U. S. NUCLEAR REGULATORY COMMISSION  
REVIEW OF IDAHO NUCLEAR TECHNOLOGY AND ENGINEERING CENTER  
DRAFT WASTE-INCIDENTAL-TO-REPROCESSING DETERMINATION FOR  
TANK FARM FACILITY RESIDUALS

**Figure 4. Illustration of the two-dimensional modeling slice used in PORFLOW**

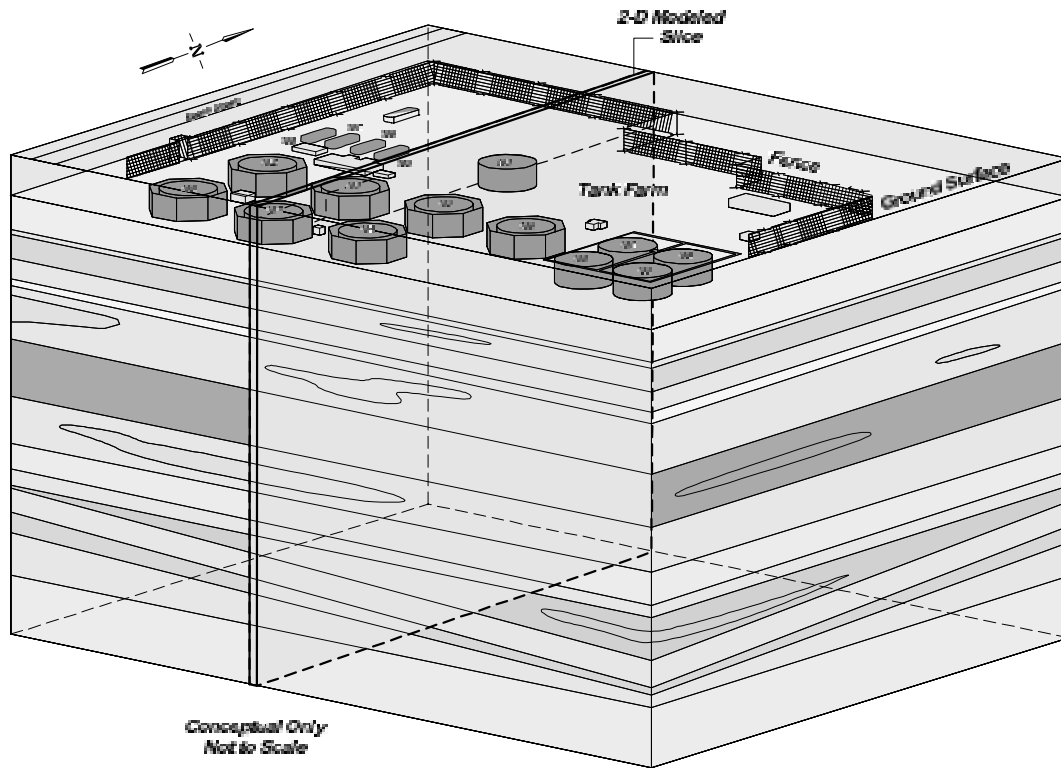
The interpretation of the results of flow and transport models for a site-specific application can be difficult when generic information is heavily relied on. Sorption coefficients used in transport modeling through the aquifer appear to have been appropriately chosen, considering the large degree of uncertainty in the absence of site-specific data. In particular, the retardation behavior of fractured basalts at the site is not well understood. Distribution coefficients can vary widely from site to site as a result of varying mineral composition and differing geochemical environments. For example, in one compendium study, the distribution coefficient for strontium ranged from 0.05 to 190 mL/g in sand; 0.01 to 300 mL/g in loam; and 3.6 to 32000 mL/g in clay [18]. DOE-ID typically assigned the minimum observed values to the distribution coefficients for interbed porous material [3]. Because this is likely to be conservative compared to the actual amount of geologic sorption, it is a reasonable approach to manage distribution coefficient uncertainty. The main exception to this approach was strontium, which used site-specific values generated from observations of radionuclide migration [35]. The use of site-specific information is preferable, as long as uncertainty associated with the development of the information is recognized and accounted for. For example, as discussed earlier, the infiltration rate at the site is uncertain. The development of strontium distribution coefficients of 12 to 24 mL/g could have been conditional on the particular infiltration rate that was used in the study.

The overall modeling approach appears to be a reasonable attempt to manage uncertain hydrologic and geologic information. It appears, in general, that DOE-ID appropriately assessed the TFF transport system through use of conservative assumptions. These conservative assumptions help to simplify the transport model as well as add confidence in the output. Conceptual model uncertainty can, in some cases, significantly impact the risk when transport is through a fractured, unsaturated hydrologic system. Confidence is gained with the DOE-ID approach as a result of the comparisons of the model predictions for tritium movement with the observations [36].
